Consultation Summary Report

Feedback analysis on Franklin Road improvement options

2 December 2015

6. Design Option 1.

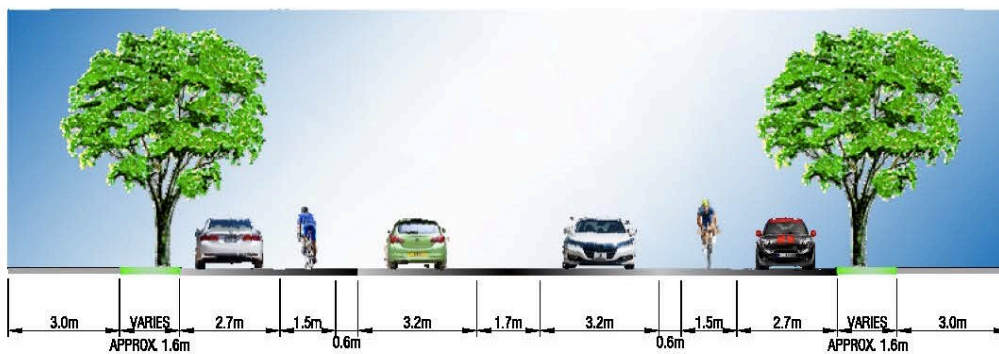
Those who made positive comments about the proposed design option 1 said they liked the retention of the median strip, retention of parking between the trees, the dedicated lane for cyclists, and the boulevard feel it maintains. Some also said that this option is safer for children exiting cars onto the pavement, and liked that it still gives cyclists the option to use the road.

Specifically, those who were in favour of the retention of the median strip in design option 1 felt it would provide a safe buffer for pedestrians to cross, with ease of turning into driveways and intersections, and that it provides space for work on services (located in the middle of the street), and additional room for extra traffic typical of the Christmas light period:

Others commented on the dedicated cycle lane, saying it was safer for cyclists, and/or liked the retention of parking between the trees (and the median strip) as this maintained the iconic boulevard feel:

However, some comments centred on the potential dangers to cyclists associated with option 1, due to a lack of separation from traffic, parked cars obscuring vehicles' view of cyclists, lack of a curb to alert drivers to a cycle lane, car doors opening, higher cyclist speeds on the downhill, and dangers at intersections. Some also disliked the retention of the median strip encouraging faster traffic speeds:

“Option 1 results in increased hazards to cyclists from cars backing out of drives (or indeed turning into them) and introduces new hazards to drivers and passengers exiting cars adjacent to cycle lanes--particularly the downhill lanes.”

“Don’t like option 1 as it retains the central flush median which is just a waste of valuable road space.”

Ref	Theme or important point from the feedback	Further description (where relevant)	AT response
General themes and important points - Design option 1			
	Support the retention of flush median strip/safer for crossing/turning/provides space for work on services/extra vehicles at xmas		Further investigation has found that most of the flush median is still required to access side streets, New World, and the approaches to the Ponsonby Rd and Victoria St intersections. It also provides flexibility for traffic management during the Christmas lights season
	Like dedicated lane/ safer for cyclists		Dedicated lanes remove the need for cyclists to share space with either cars or pedestrians creating a safer street for all users
	Dangerous /no separation/cars pulling out of driveways/car doors/encroachment		Option 1 provides for more confident cyclists and is appropriate for steeper gradient on Franklin Road. It provides good separation between cyclists and cars reversing out of driveways and includes a buffer between the cycle lane and adjacent traffic lane. Indented car parking provides extra space between open car doors and the adjacent cycle lane

7. Design Option 2

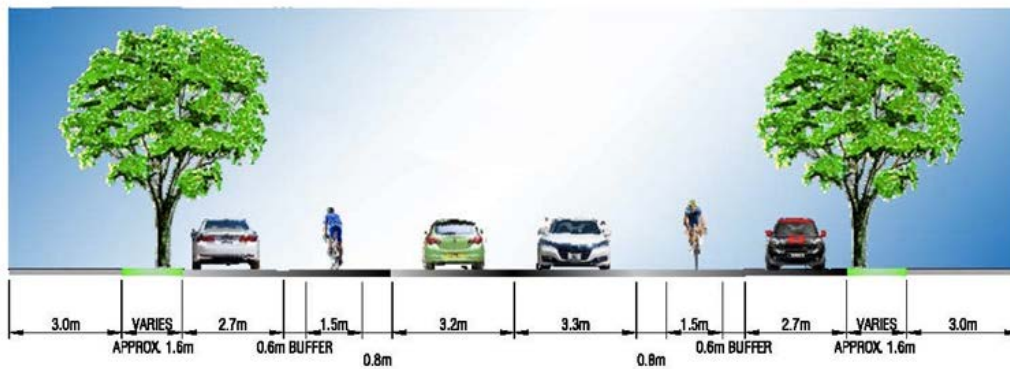
While there were fewer comments specifically regarding design option 2, some people said they liked the wider dedicated cycle lane for improved safety generally and the buffer it offered for protection from car doors as cyclists travelled downhill:

“Better for cyclists with wider cycle lanes than Option 1. Dislike: Not as good for cars with lack of right hand turn median strip into side streets with no median strip.”

However, some perceived the design to be dangerous due to the lack of separation between the cycle lane and cars, the likelihood of encroachment by cars, the lack of a raised curb to alert drivers to the lane, cyclist speed (due to a more road-like design), and dangers from parked cars obscuring a vehicles view of cyclists:

“Option 1 and 2 are just more of the same old Auckland style infrastructure, they’ll be double parked in, used for left turns and will be regularly encroached by drivers at high speed going up and down Franklin Rd.”

Some disliked the loss of the median strip from this design:

“Were option 2 selected, I would like to see physical separators between the bike and car lanes, like Beach road (i.e. the black raised rubber strips).”

Ref	Theme or important point from the feedback	Further description (where relevant)	AT response
General themes and important points - Design option 2			
	Dangerous/ no separation/ cycle lanes will be encroached by cars pulling out of & into driveways		Option 2 provides separation between people on bikes and vehicles which are driving, parked, and exiting driveways and minimises risk to cyclists and pedestrians. It provides the greatest distance between cars reversing out of driveways and the cycle lane
	Dislike loss of median strip/right hand turn/ will clog traffic		Further investigation has found that most of the flush median is still required to access side streets, New World, and the approaches to the Ponsonby Rd and Victoria St intersections
	Like dedicated lane/wider/safer for cyclists & other modes		Dedicated lanes remove the need for cyclists to share space with either cars or pedestrians creating a safer street for all users
